Project	IEEE 802.16 Broadband Wireless Access Working Group < http://ieee802.org/16 >	
Title	Enhancements of Space-Time Codes for the OFDMA PHY	
Date Submitted	2004-07-07	
Source(s)	Erik Lindskog, V. Shashidhar, B. Sundar Rajan, Djordje Tajkovic, David Garrett, K. Giridhar, Bob Lorenz, Babu Mandava, A. Paulraj, Taiwen Tang, Tareq Al-Naffouri, Erik Stauffer, Trevor Pearman, Kamlesh Rath, Aditya Agrawal, Mai Vu Beceem Communications, Inc. Freedom Circle, Suite 101 Santa Clara, CA 95054	Voice: +1-408-387-5021 Fax: +1-408-496-0040 elindskog@beceem.com
Re:	802.16e/D3	
Abstract	Low decoding complexity improved space-time codes with full rate and full diversity for 4 Tx – rate 1 configuration.	
Purpose	To propose enhancements of the space-time codes in 802.16e/D3.	
Notice	This document has been prepared to assist IEEE 802.16. It is offered as a basis for discussion and is not binding on the contributing individual(s) or organization(s). The material in this document is subject to change in form and content after further study. The contributor(s) reserve(s) the right to add, amend or withdraw material contained herein.

Enhancements of Space-Time Codes for the OFDMA PHY

Figure 1: Performance comparison for 4Tx-Rate 1 the current matrix A in the standard and proposed matrix A_1 for Pedestrian-B channel model, QPSK modulation, and Tail-biting Convolutional Code with Hard Decision Decoding.

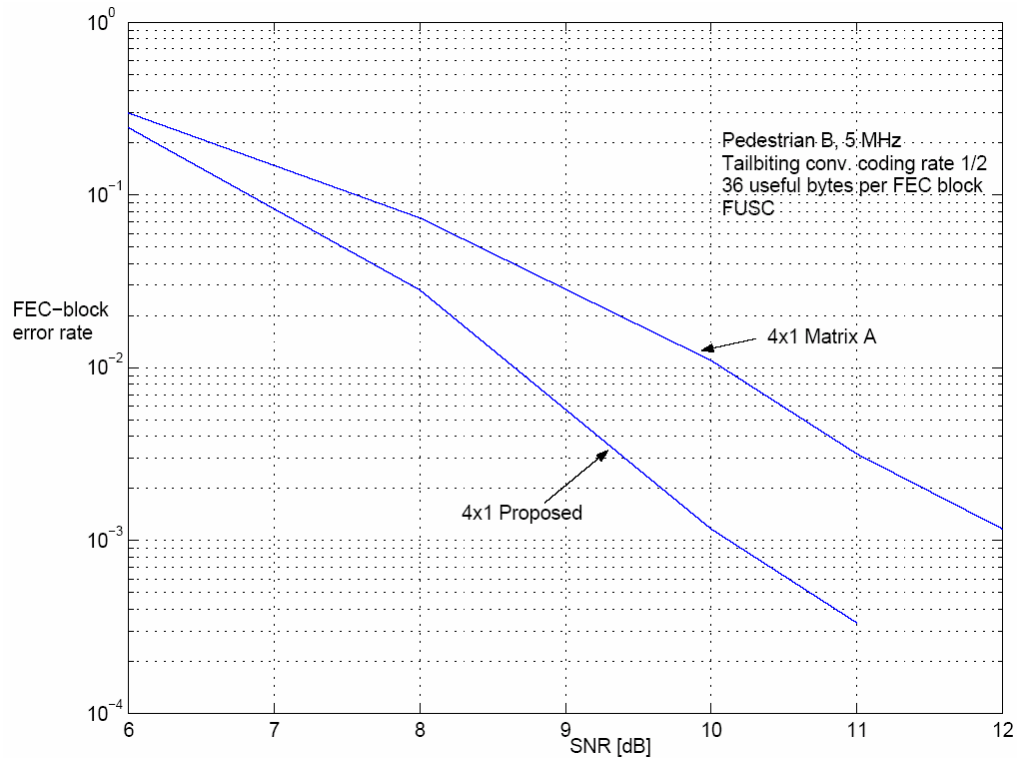
This proposed change is guided by the following reasons: (i) The transmit diversity gain of A_1 is 4 whereas that of A in [1] is only 2; (ii) A_1 admits a decoupled symbol by symbol decoding for the variables which leads to a fast ML decoding (analogous to the Alamouti code for 2Tx). Fig. 1 shows the performance of this code using decoupled ML decoding of low complexity for QPSK.
